ADDENDUM NO. 1

PROJECT NO: 1110169

TITLE OF PROJECT: Visitor Center Repairs and HQ Restroom Replacement

FACILITY LOCATION: Monahans Sandhills State Park

4 Section House East Exterior Elevation
SCALE: 1/4" = 1'-0" REF: A-13

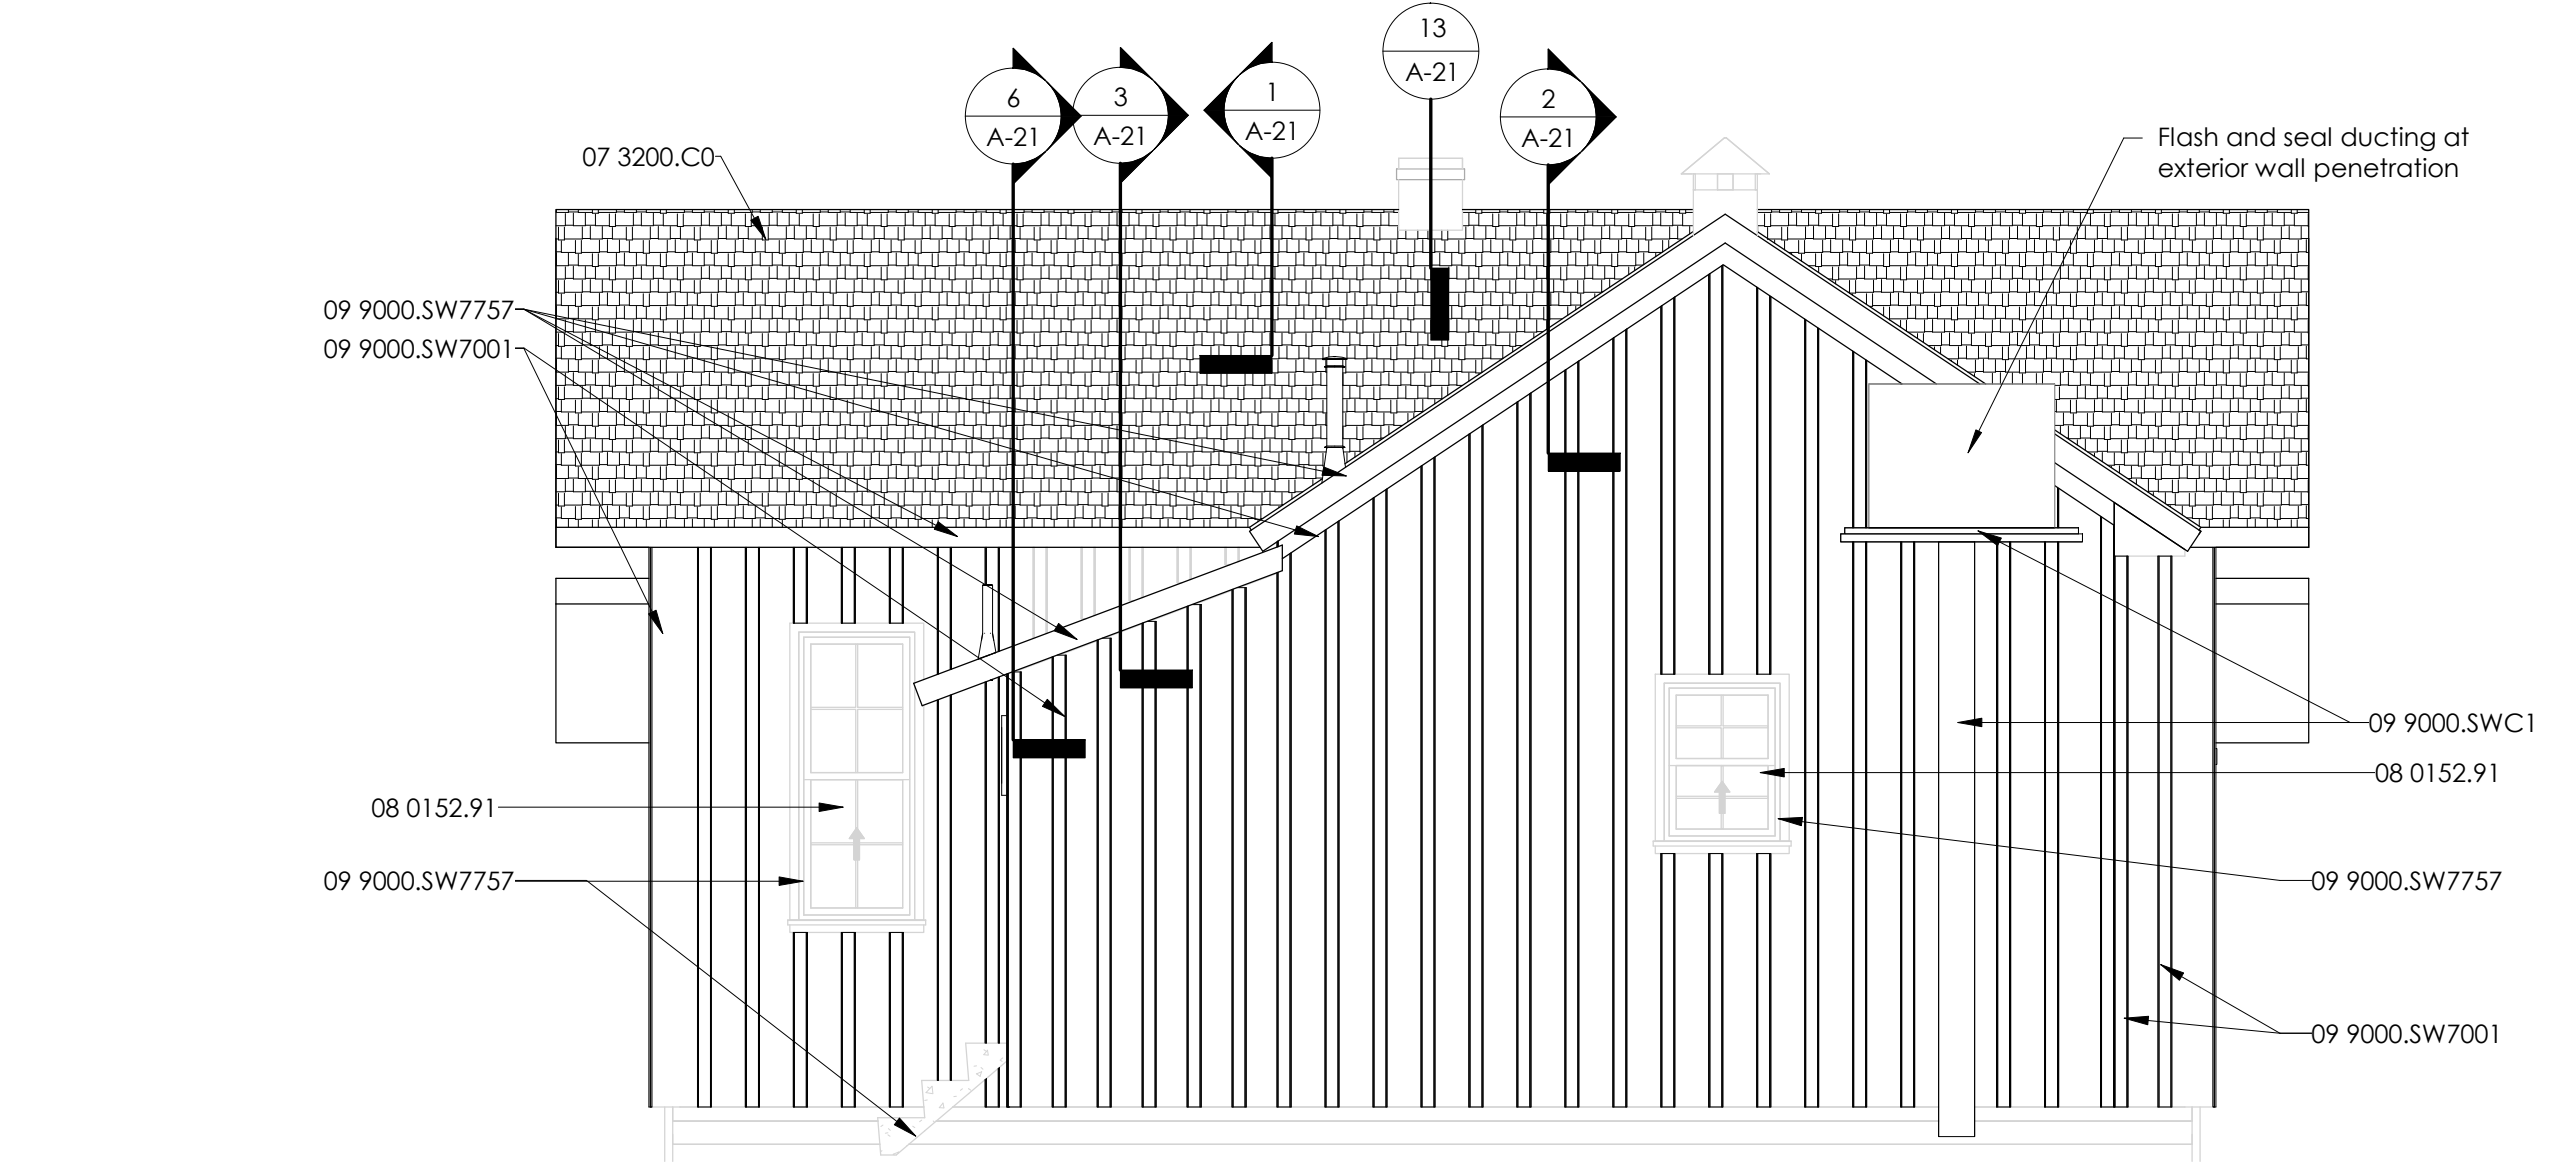
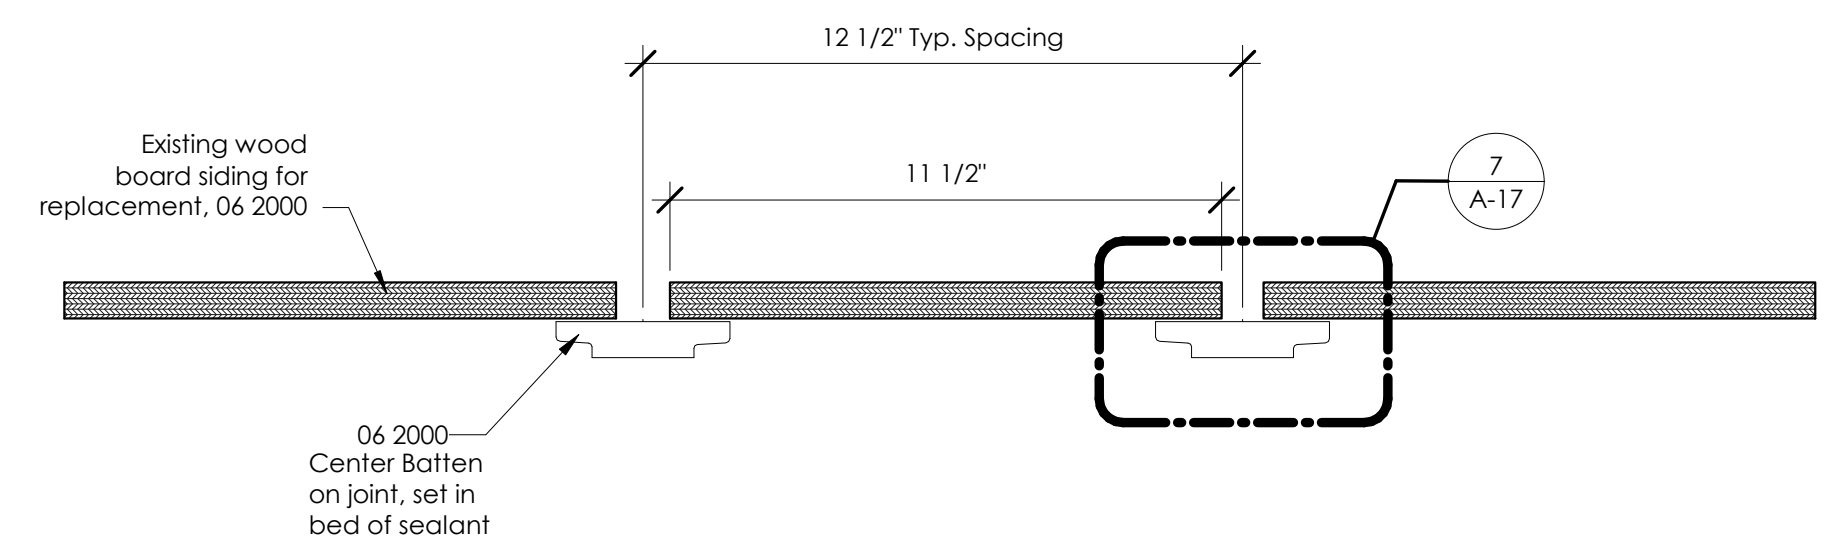
Q: Will the exterior electrical that is surfaced mounted need to be addressed on how to bid?
Please see attached photos

- Surface mounted conduit and boxes that are currently painted the sand color is to be painted color to match surface to which it is attached or nearest surface (e.g. conduit run along underside of porch paint to match soffit/rafter color)

- For exterior electrical outlets where the exterior enclosure has been painted sand, paint the enclosure to match surface to which it is attached. Mask off outlet.

- For wall mounted light fixtures, mask off fixture.
- For under soffit light fixtures at porch, remove light fixtures prior to painting and reinstall after painting complete.
